Planning Commission Regular Meeting

Wednesday, December 06, 2023 at 6:30 PM

- [A.](#) Staff Report 23-060, Request for Conditional Use Permit CUP 23-08 for a Planned Unit Development at 1563 Homer Spit Road, 1663 Homer Spit Road, and 1491 Bay Avenue.

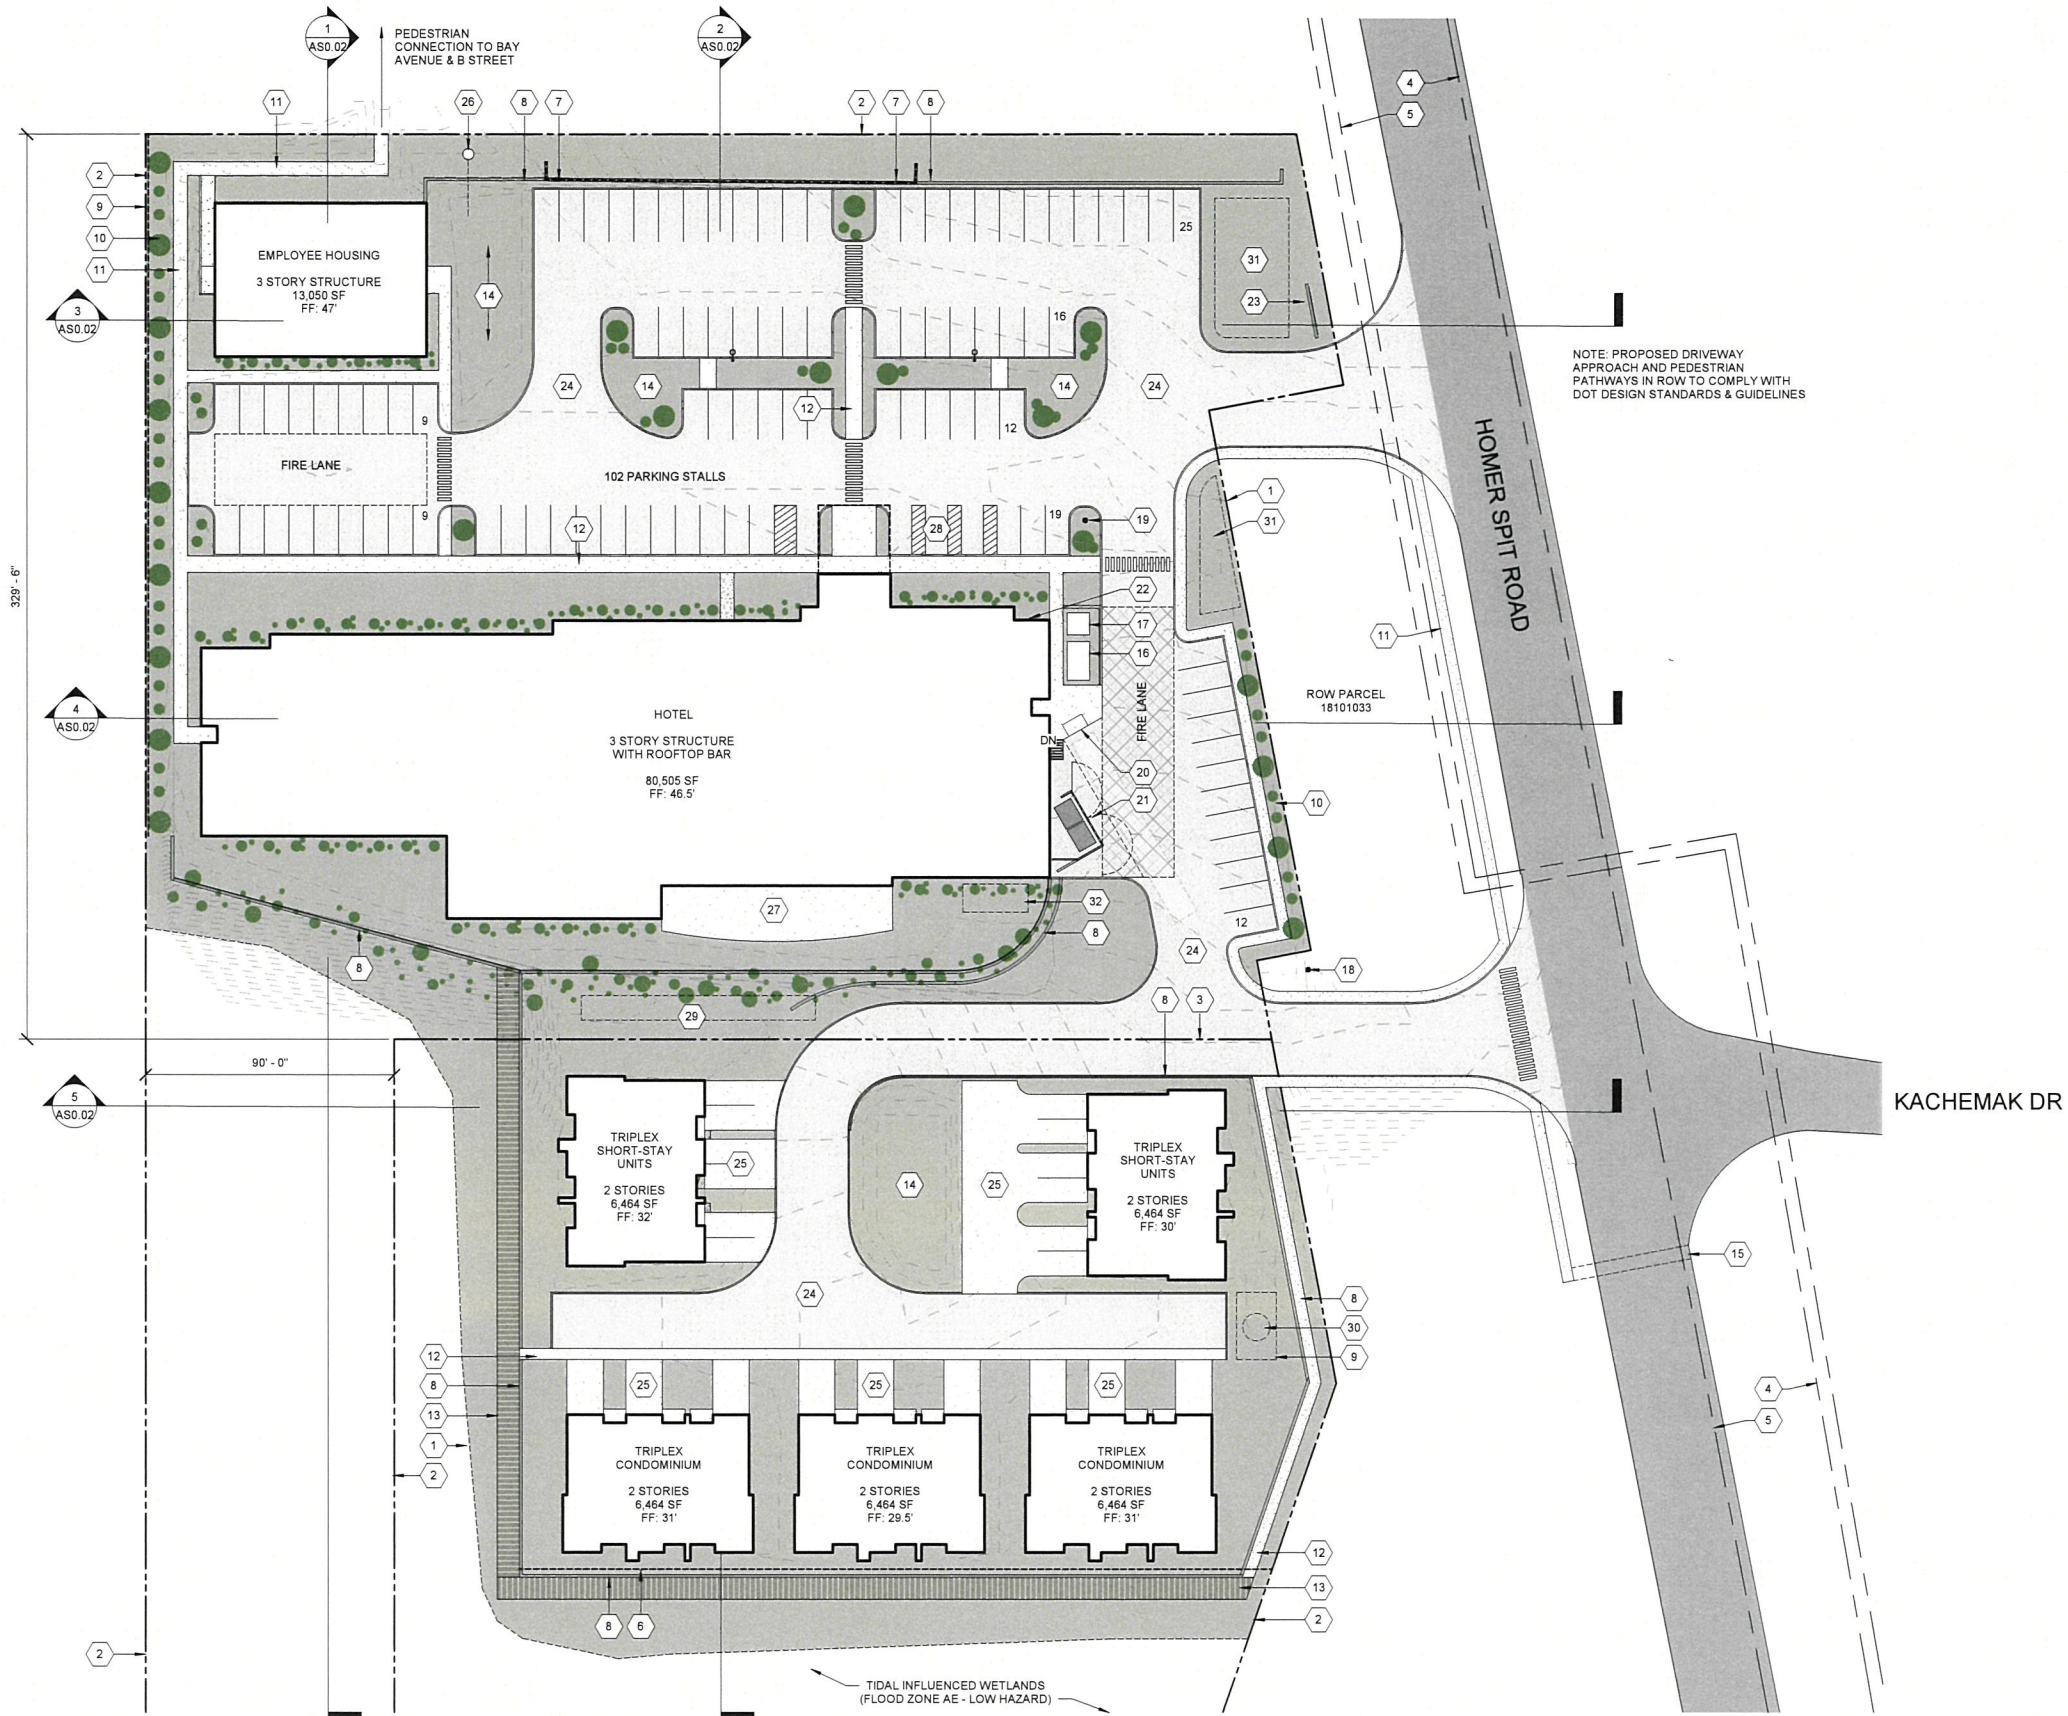
2. Specify that trees not directly within the development footprint should be preserved.
- j. Sheet U0.00 shows minimum depths of bury that seem too shallow.
 - Recommendation: Verify minimum depths of bury with Jean Arno.
 - k. Sheet U0.00 has a grease trap interceptor, for the commercial kitchen, which is a good thing.
 - Recommendation: Property owner should provide details of construction & maintenance for this device.
